Exhaust Gas Recirculation (EGR) Valve Oil Supply Line

VN, VHD, VAH
D11H

FSB 293-016, Exhaust Gas Recirculation (EGR) Valve, Oil Supply Line

(November 2012)

W2077816

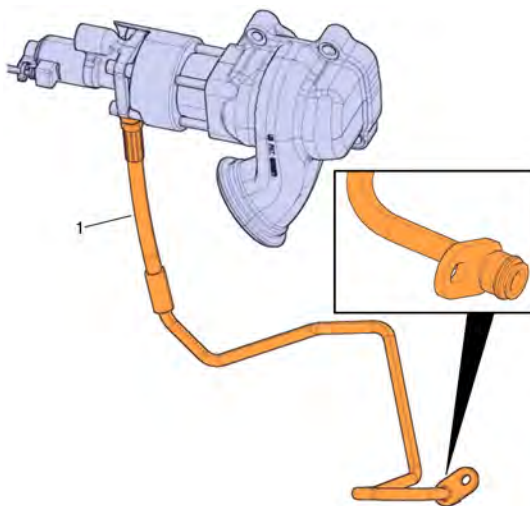
VOLVO Truck chassis built prior to AUG 14 2012 with D11H (US10 emissions) engines built prior to engine serial number 547267 were assembled with Exhaust Gas Recirculation (EGR) valve oil supply line (part number 21183591) with the formed tube fitting. The old EGR valve oil supply line with the formed tube fitting is now replaced by the new oil supply line (part number 21544061) with the machined fitting brazed onto the end of the tube to prevent oil leaks at the oil filter housing.

Note: The existing supply line has the retaining plate swedged onto the tube. The new supply line has a brazed fitting and a floating retaining plate.

Note: Do not replace the EGR valve oil supply line unless there is an oil leak in the oil supply line fitting at the oil filter.
